This page lists the known errors on the gm5x5x5 PCBs. There are no known issues with the bulk order run (white PCBs), the following information is valid **only** for the prototype run (green PCBs).

#1 Silkscreen error

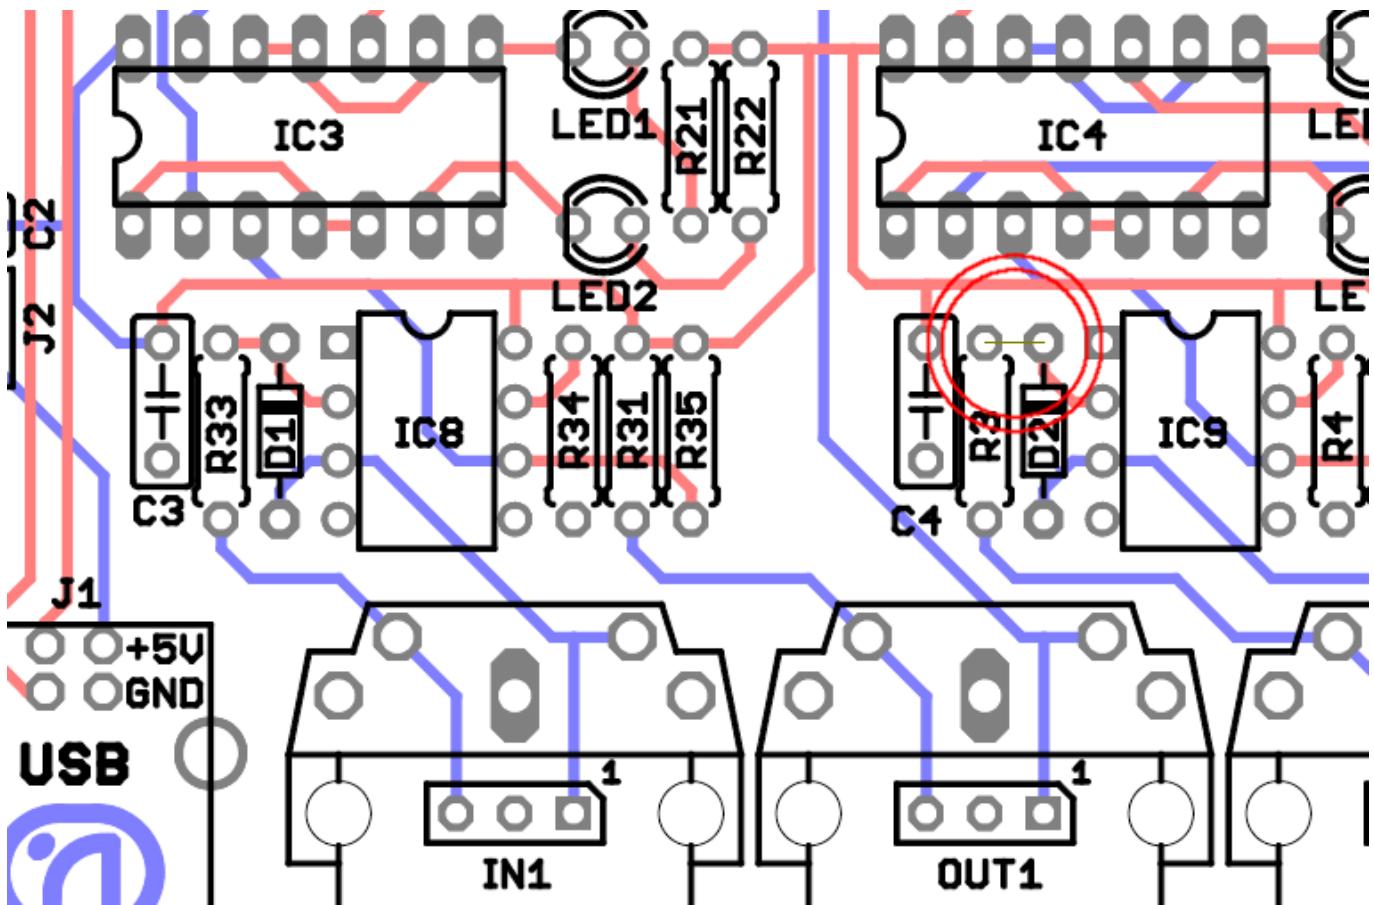
Problem: The silkscreen has the EEPROM the wrong way around - Pin 1 should be facing IC5.

Solution: Stick the EEPROM in the other way around, with the "notch" facing IC5.
